September 6, 2016

ATTN: Harbor Comments

Portland Harbor Superfund Site
Swan Island Sediment Decision Unit Optimized Remedial Alternative

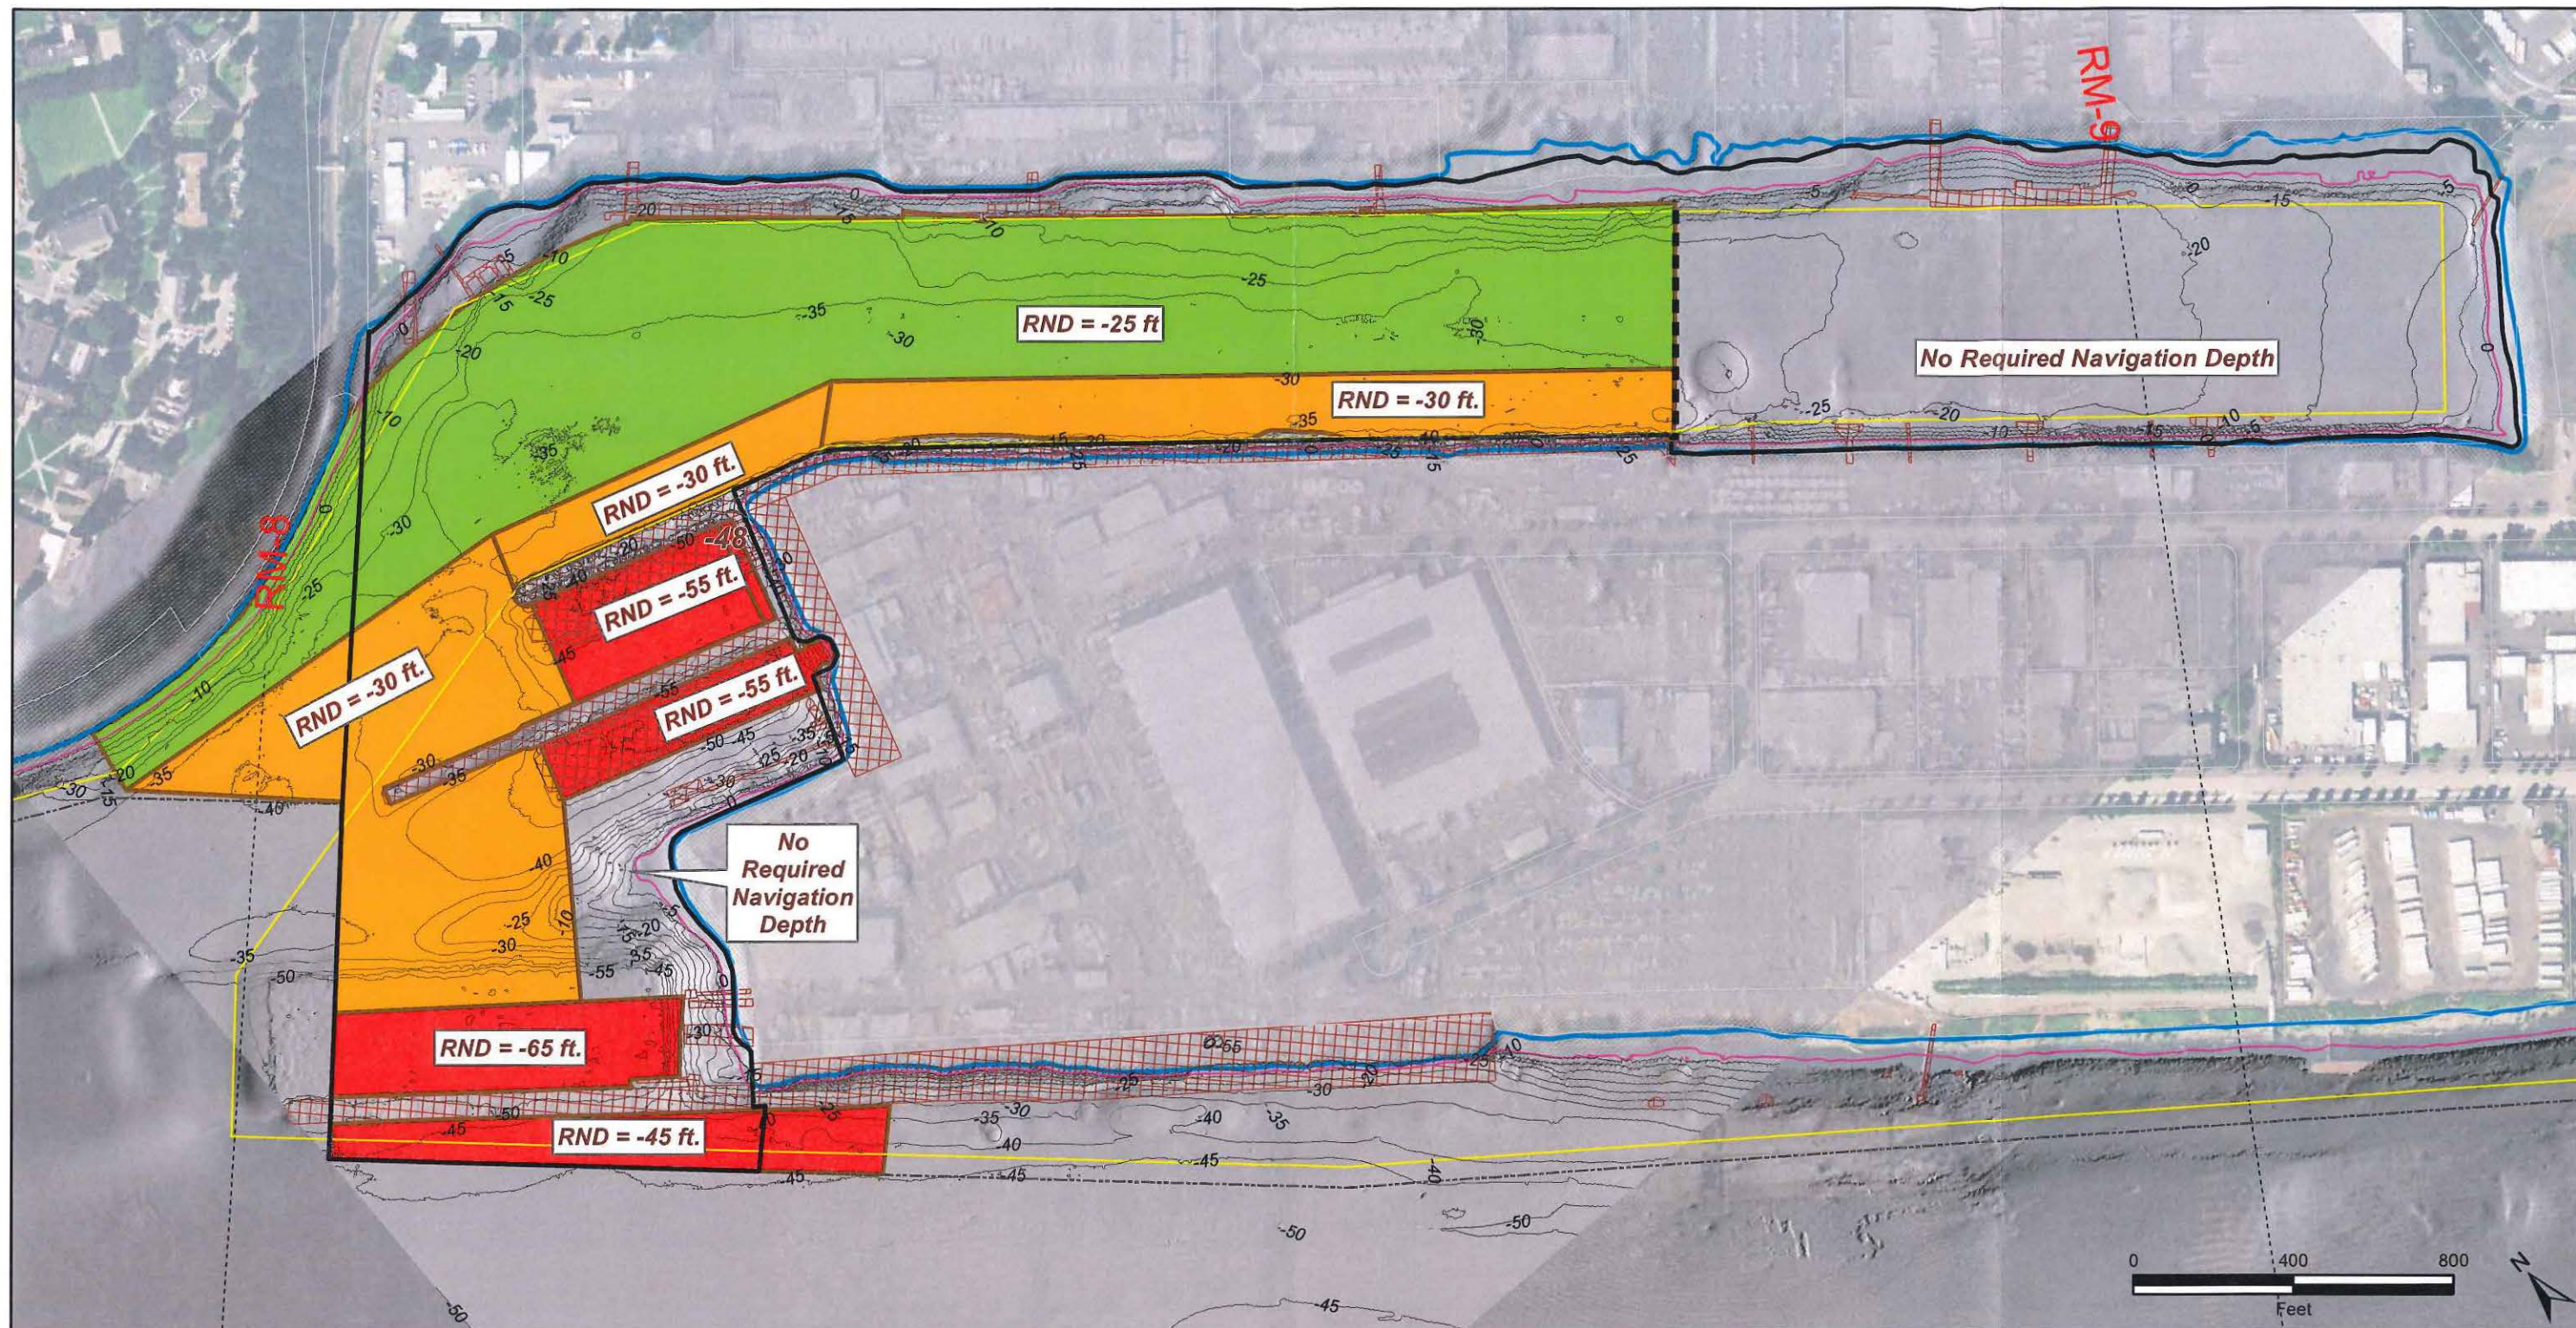
1. Removal of the FMD designation for the head of the Swan Island Lagoon past shipyard Berth 305 and for the mouth of the lagoon outside of the SI SDU.
2. Removal of the FMD designation near the SI Shipyard Ballast Water Treatment Plant bank slope.
3. Updating of navigation depth requirements as noted on Figure 1.

FIGURE 2
AREAS OF
THE SWAN ISLAND SDU
THAT ARE ABOVE REQUIRED
NAVIGATION DEPTHS

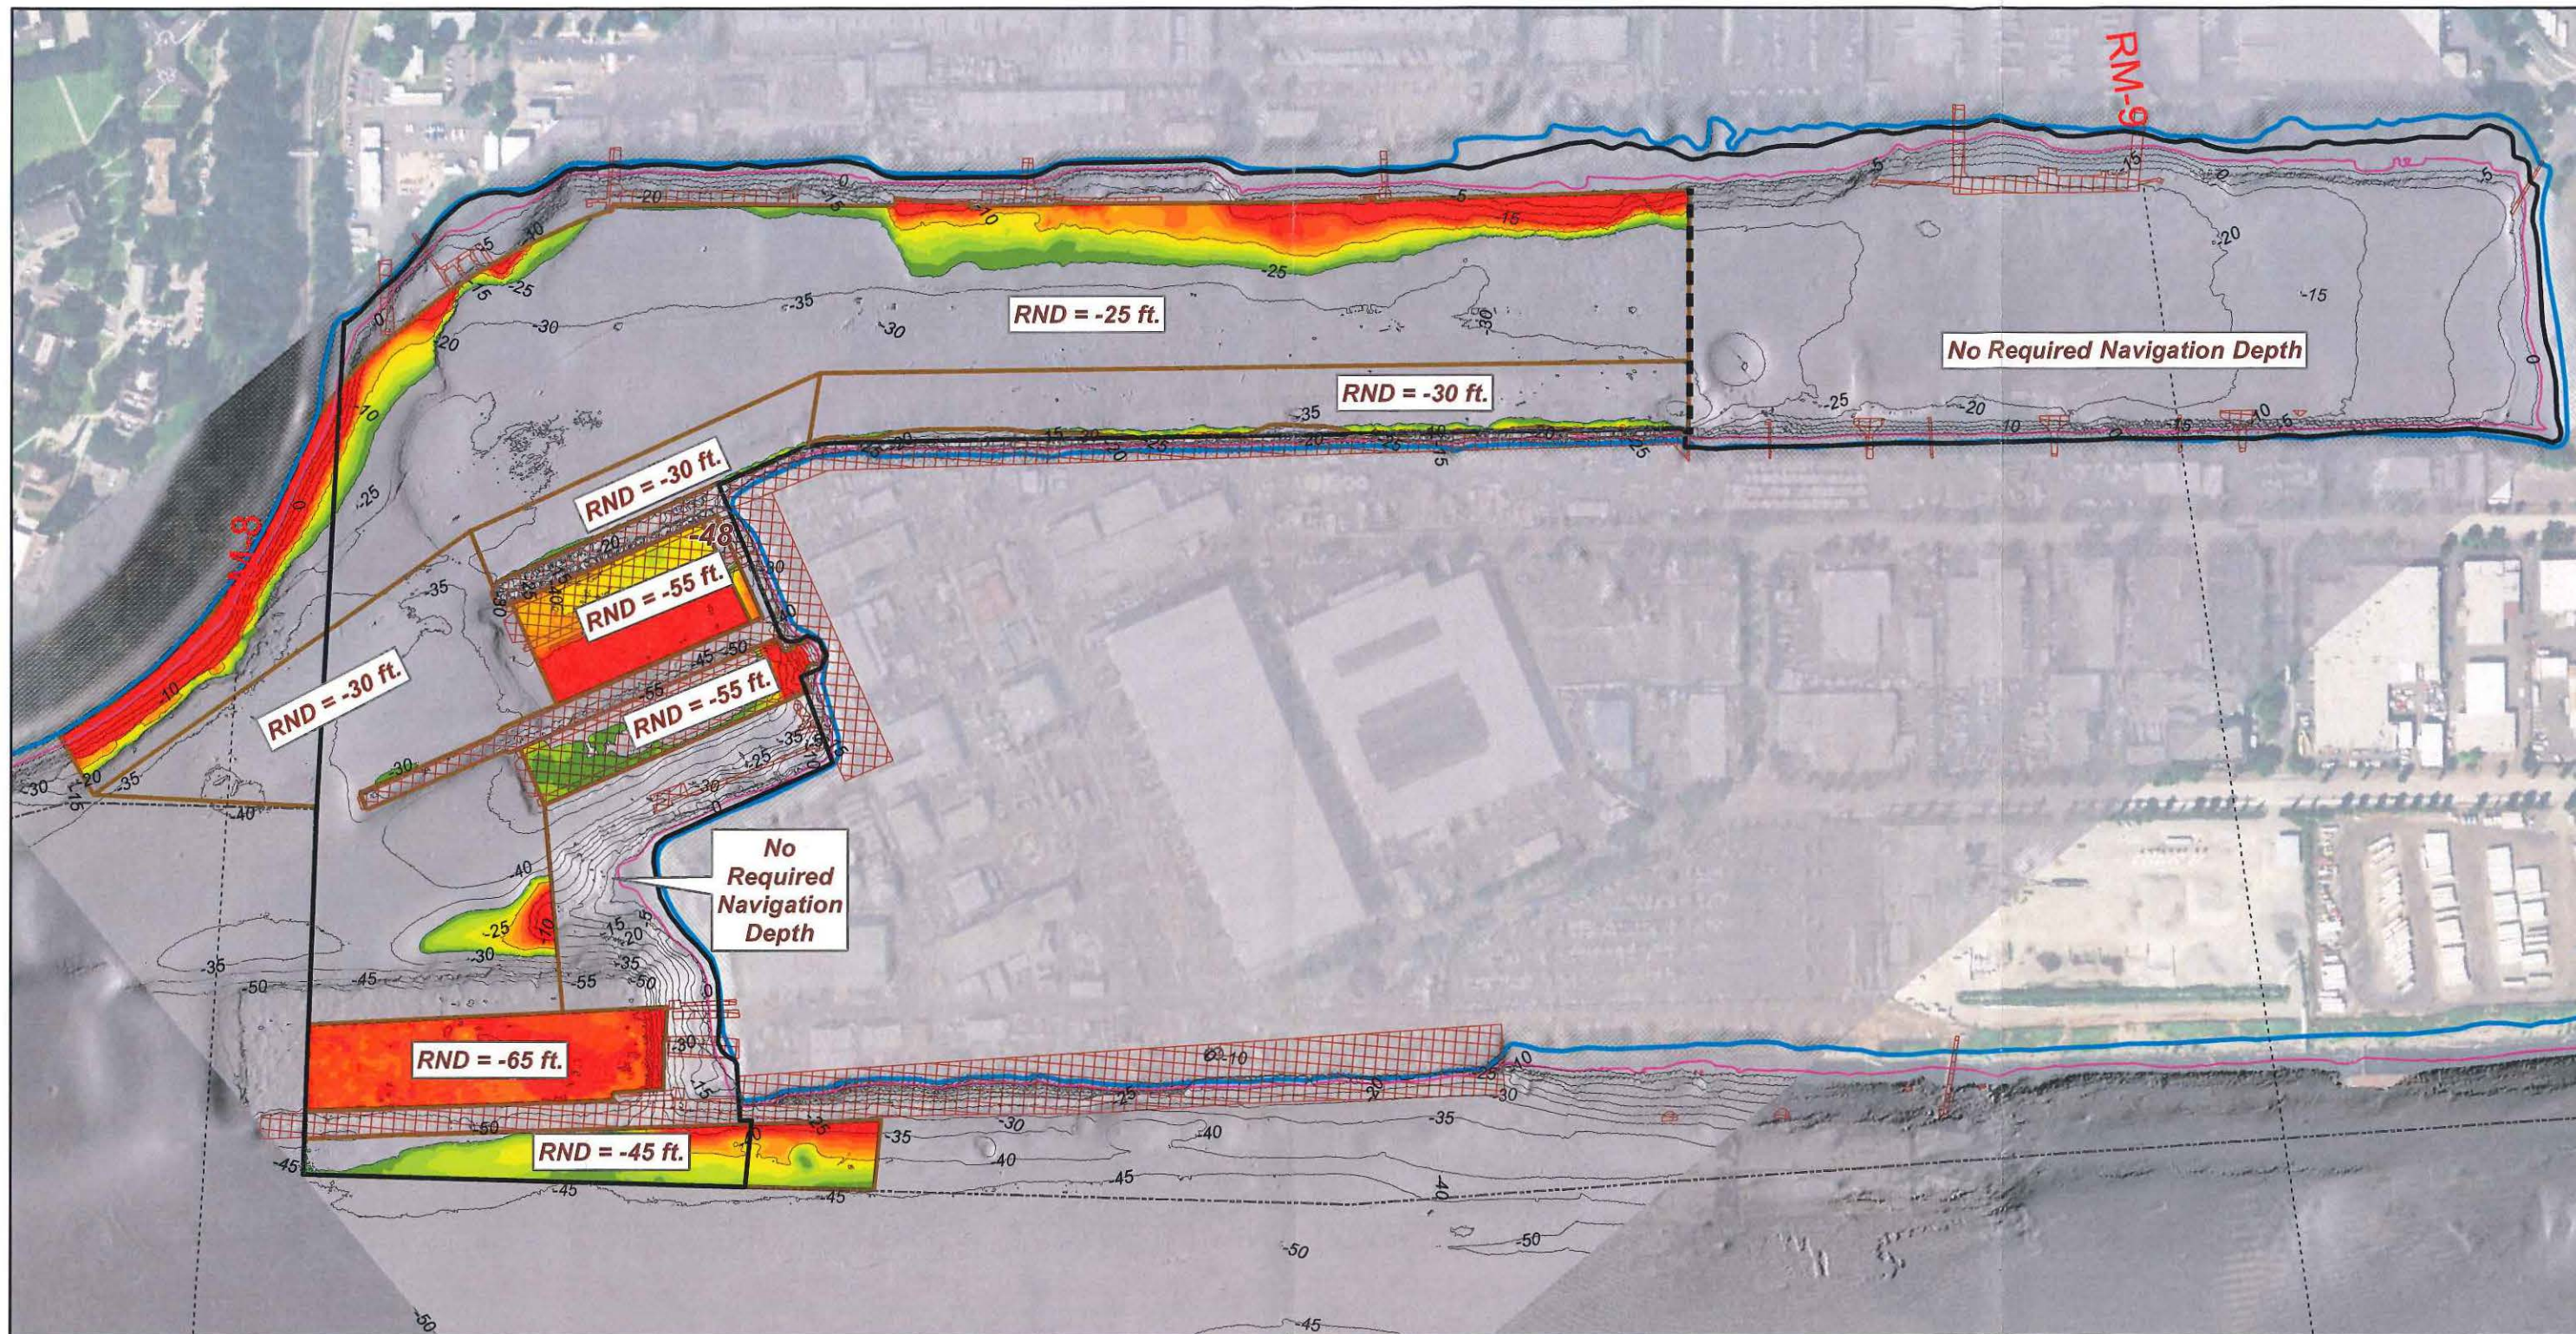
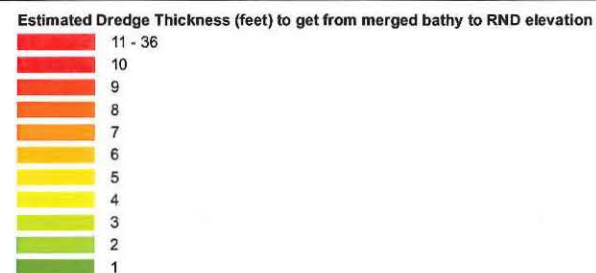
Bathymetry from recent surveys in the SI SDU shows that current depths in a large portion of the area designated by EPA for dredging in Alternative I are at or greater than the navigation requirements (Figure 2). Further, the existing sediment surface is sufficiently deep that in-place technologies such as capping, ENR, or MNR could be utilized in much of the lagoon without exceeding target navigation depths for current and future uses or being adversely affected by navigation activities. In some discrete areas along specific berths, limited dredging may be needed to allow capping or placement of ENR layers if the depth of contaminated sediment were to exceed 3 feet below the mudline or on the basis of other site specific factors (e.g., geotechnical considerations, or structural offset requirements).

Figure 3

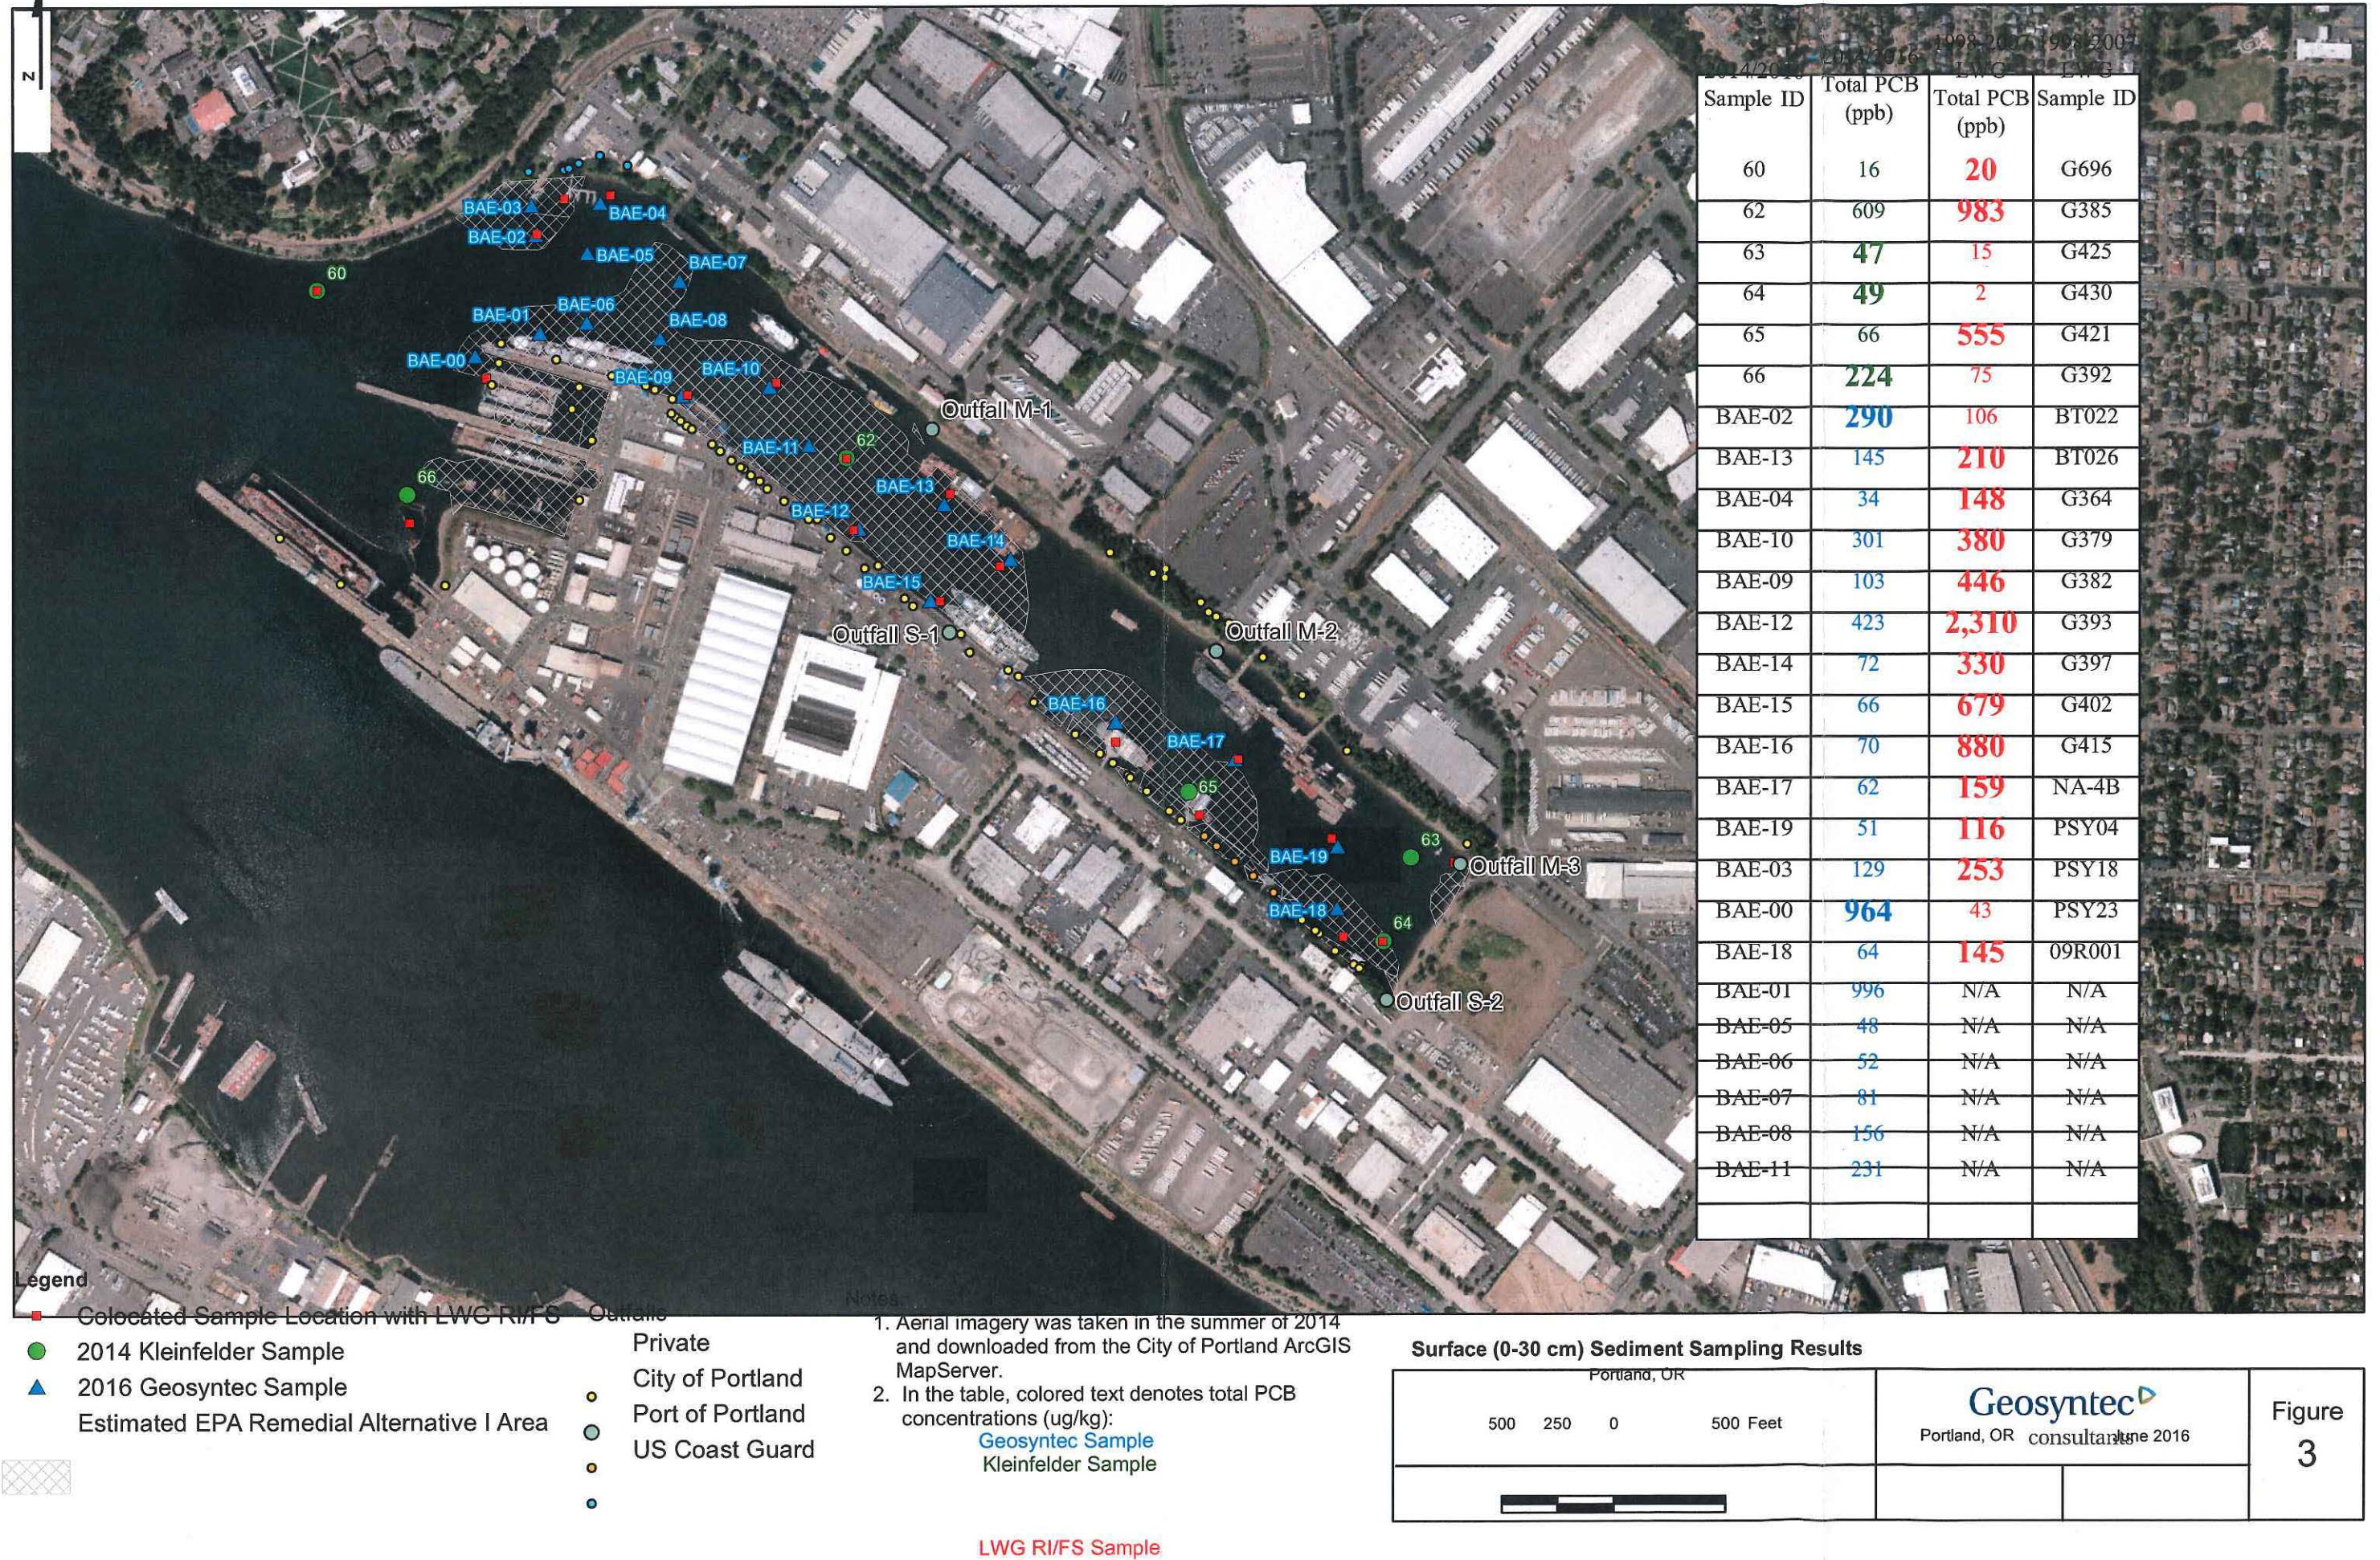
Data collected during recent sampling efforts show that PCB concentrations in the SI SDU surface sediments are mostly lower than what was used in the FS evaluation (Figure 3). Twenty-six additional samples collected from 2014 to 2016 were co-located with previous sampling locations for data that were used in the FS (Geosyntec, 2016). Seventy-five percent of these samples show reduced PCB concentrations. This trend is supported by PCB concentrations measured in smallmouth bass from the SI SDU as part of a fish tissue sampling event ordered by EPA in 2012 (LWG 2013). The average PCB concentrations were nearly seven-fold lower in fish samples than reported for the RI sampling in 2002/2007. RI fish tissue samples collected in 2002 and 2007 had a mean PCB concentration of 3,026 µg/kg, whereas the mean concentration from the 2012 sampling was 447 µg/kg.
